# 100 Mount Street, North Sydney (MP08-0241)

Section 75W - MOD 2  
Environmental Assessment Report

December 2013

FIGURE 11 – LOWER GROUND LEVEL

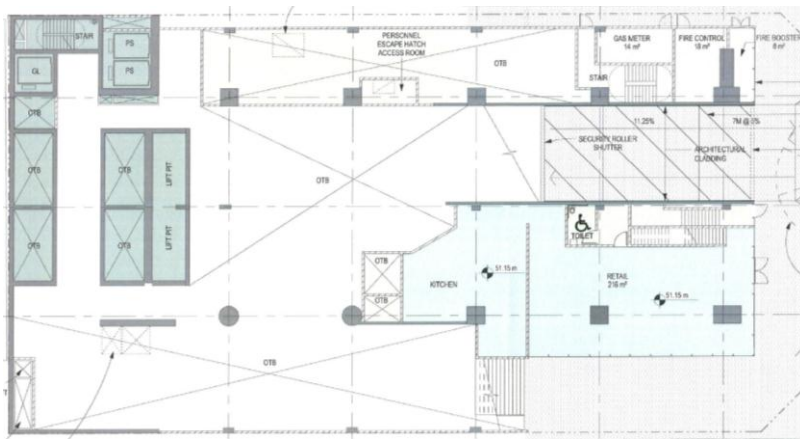
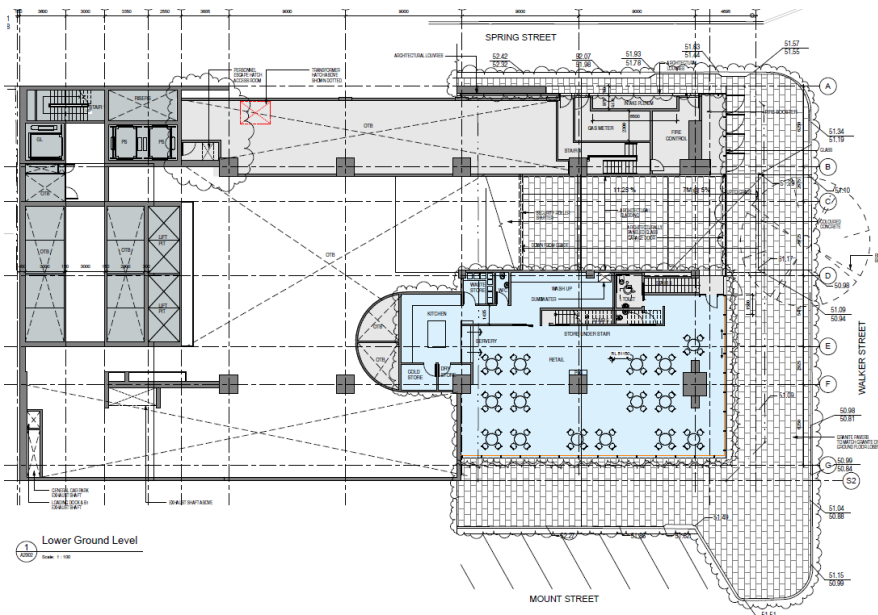
- Minor realignment of the south eastern corner of the ground floor level;
- Removal of stairs along Mount Street, facing Walker Street, leading between the lower ground and ground floor levels. These stairs are redundant, due to increased gradient of stairs to lobby at ground level from Mount Street;
- Increase in the size of the retail/café area;
- Replacement of a portion of the café's glass roof with a solid roof to accommodate additional seating above on the ground level;
- New door openings proposed to fire control room; and
- Granite pavers of public domain (Walker, Spring and Mount Street pavements) to match that of the ground floor lobby paver surface to integrate these spaces. The granite paving selection is to be discussed and agreed with NSC.

FIGURE 12 – GROUND FLOOR

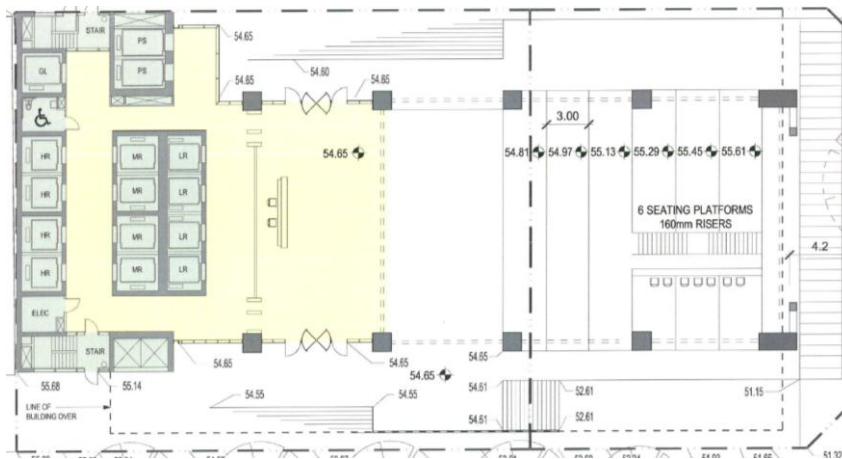
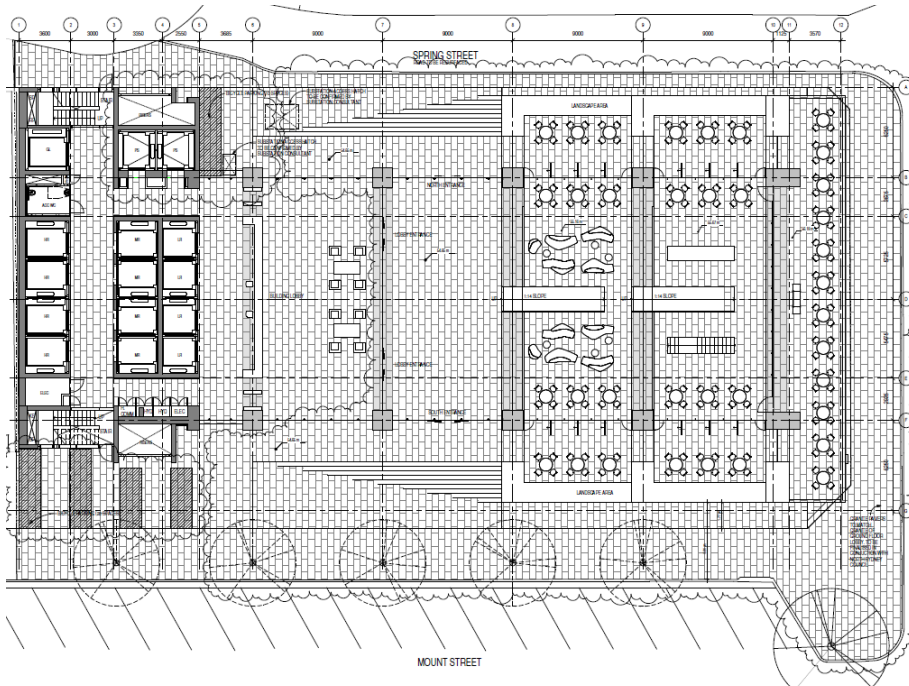
- The ground floor level is extended outwards in the eastern portion of this level to provide additional space for seating and landscaping to enhance the public / commercial space and encourage its use. The modification will improve this space and make it more defined, integrated and accessible;

- Removal of stairs running along Mount Street and facing Walker Street, leading between the lower ground retail and ground floor levels. The Mount Street facing stairs are to be enhanced by increasing the number of risers and replicate those stairs facing Spring Street. The gradient of the modified Mount Street facing stairs are reduced to enable enhanced movement between levels;

- 28 external bicycle spaces added to the south western corner of the site, while 10 spaces added to the north western corner of this level. This will provide public bicycle parking;

- Public domain granite pavers will match that of the ground floor / lobby surface, integrating these spaces. The granite paving selection is to be discussed and agreed with North Sydney Council; and

- The carpark lifts are modified to open southwards rather than eastwards as was approved.

FIGURE 13 – GROUND FLOOR

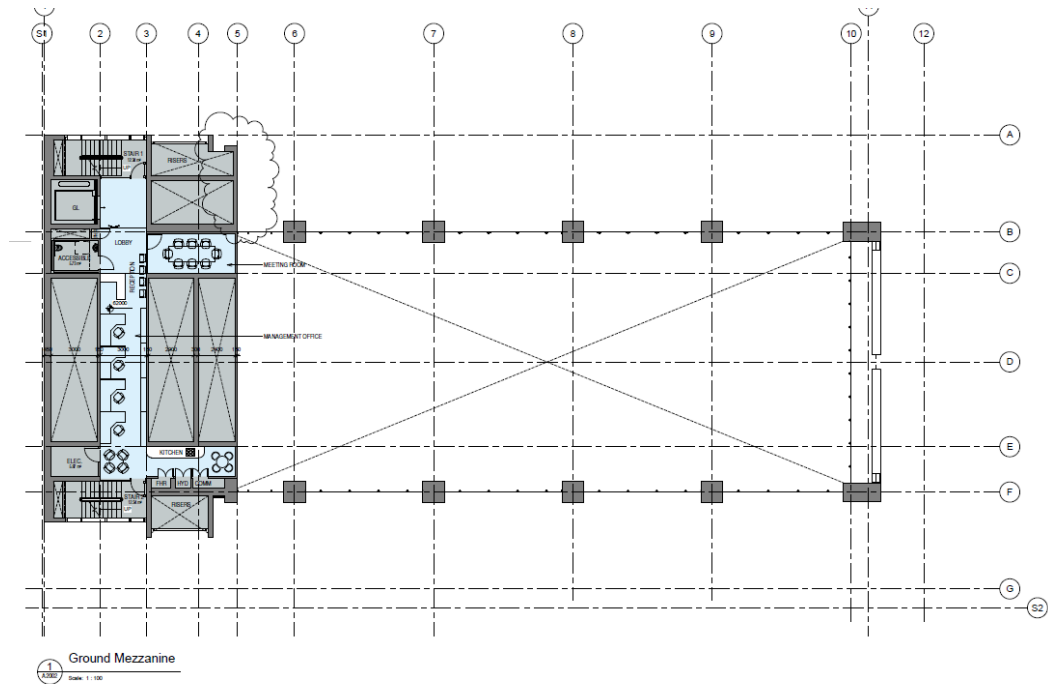
A Ground Floor Level Mezzanine is proposed to be introduced to accommodate a building manager's office on the western side of the building.

FIGURE 14 – LEVEL 1 AMENITIES

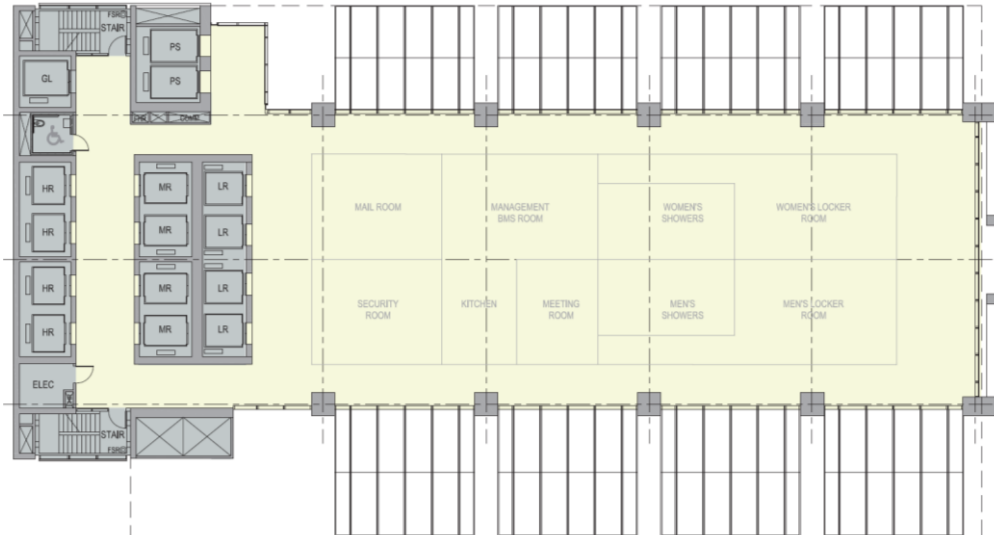
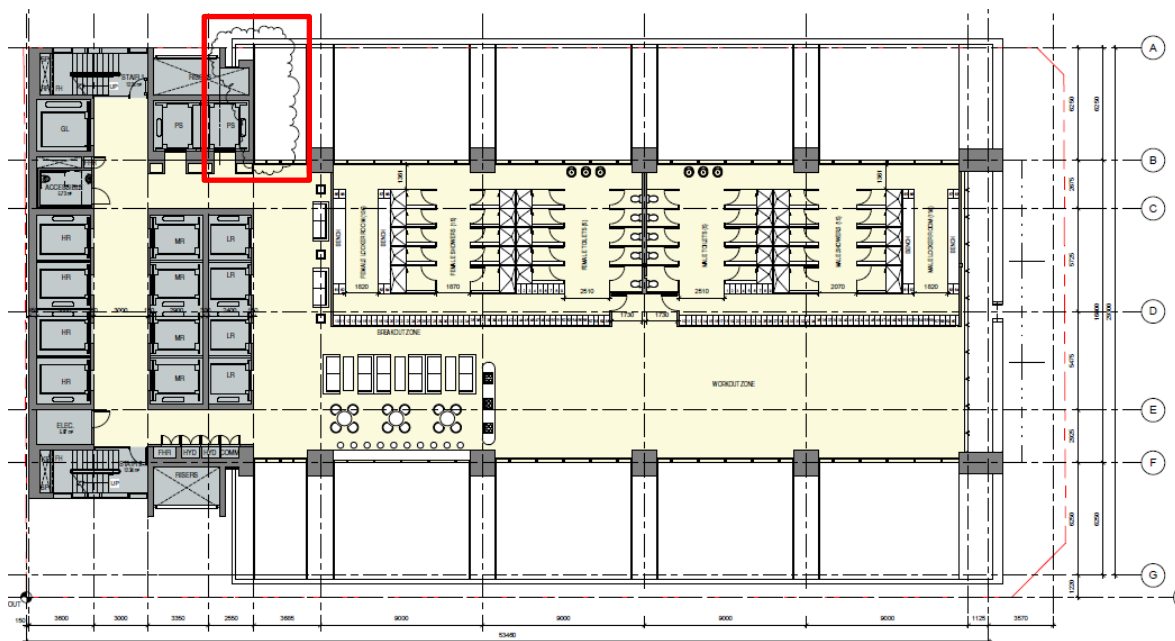
Lifts in the north western corner of this level are realigned with their doors facing southwards rather than eastward as approved. This enables the removal of a redundant lift lobby landing area.

- FIGURE 15 – PLANT LEVEL

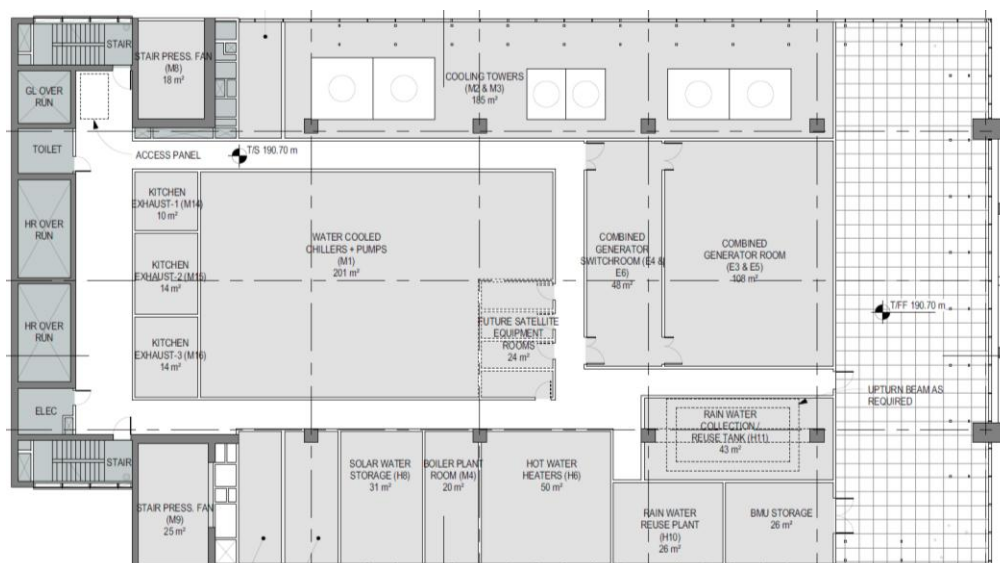
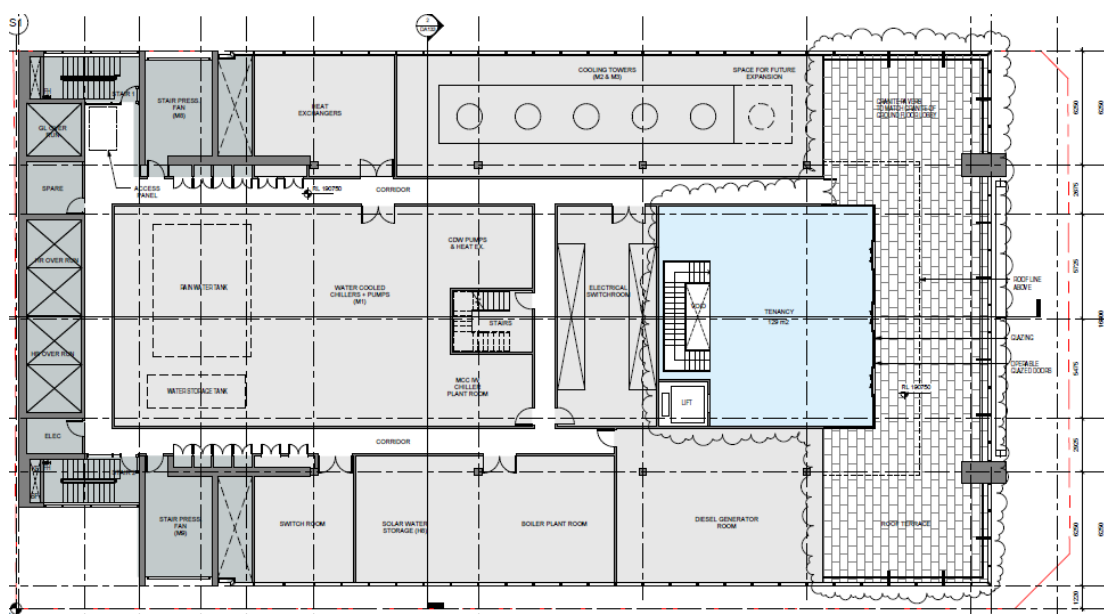
The following modifications are proposed for the plant level:

FIGURE 16 – PROPOSED PLANT MEZZANINE LEVEL

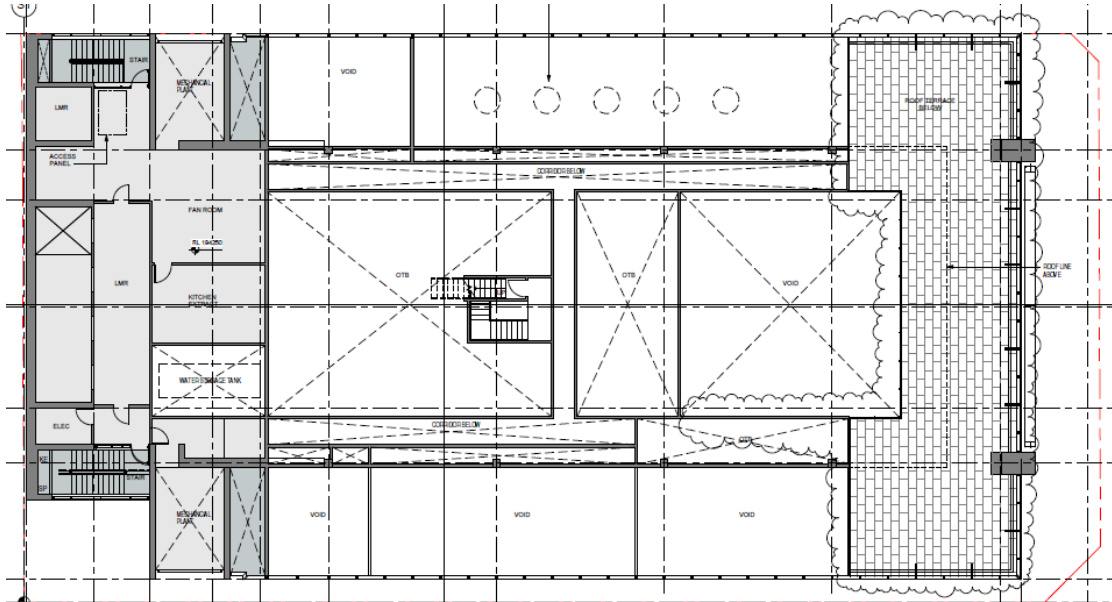
A new mezzanine level proposed to the building. This level will include additional plant rooms and voids (creating double volume for the new proposed plant level tenancy) above certain portions of the plant room level below. This is required due to the spacing requirement of the plant equipment selected. The roof terrace will not include any structures above it and will be open to the sky.

FIGURE 17 – ROOF PLAN

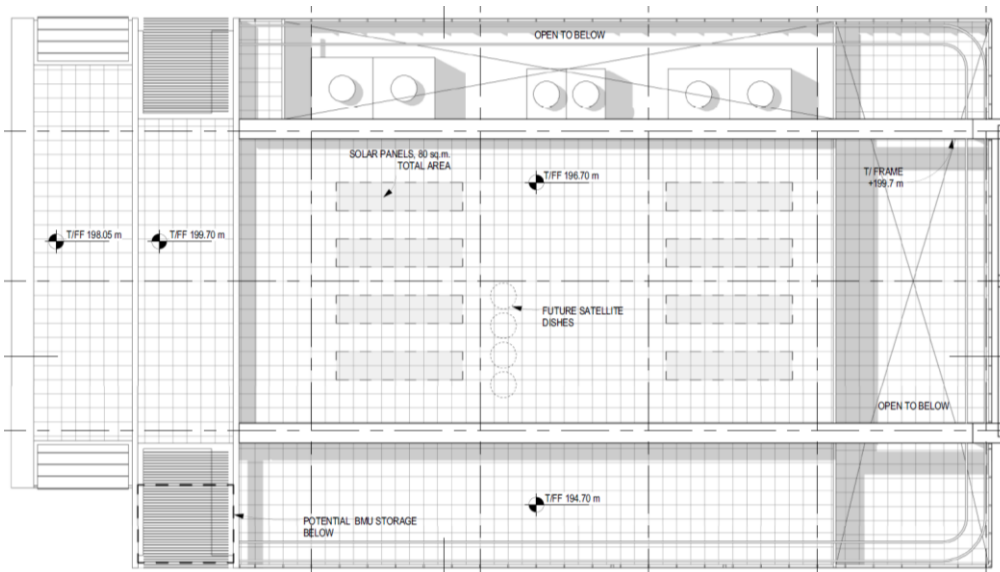
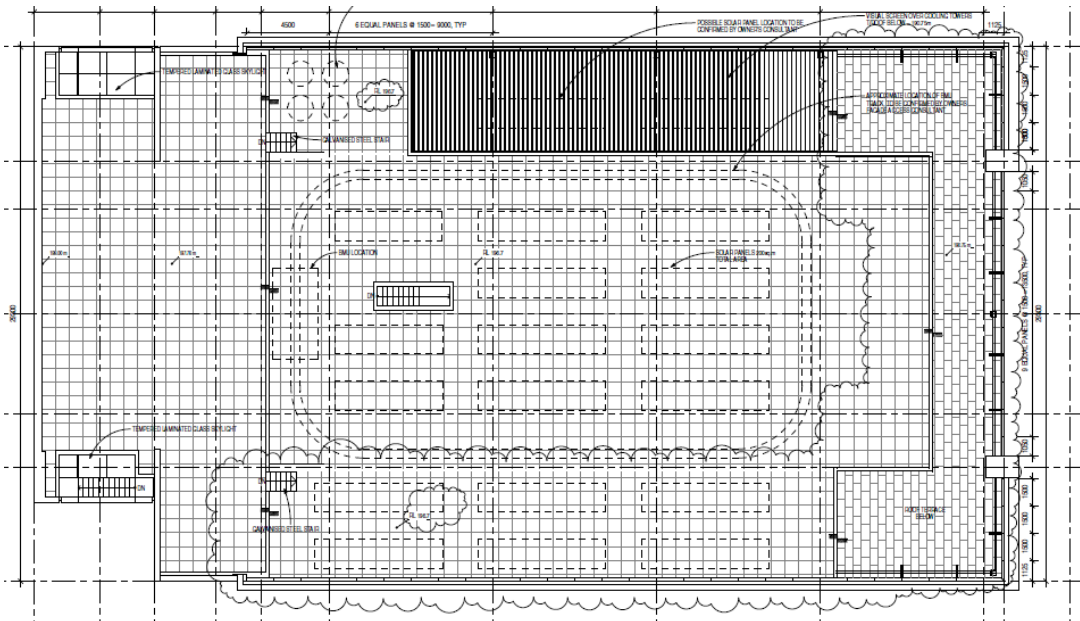
- Portion of roof area to be raised from approved RL194.70 to RL196.7, but remains below the maximum approved height of RL199.7. It is noted the maximum height of the approved development is proposed to be reduced to RL198;
- New staircases added to provide access to the roof;
- New BMU track to allow for cleaning of the facade;
- New screens to be provided to cooling towers; and
- Plant and frame structure to be removed from over the new roof terrace area to provide for a more attractive and functional outdoor terrace space.
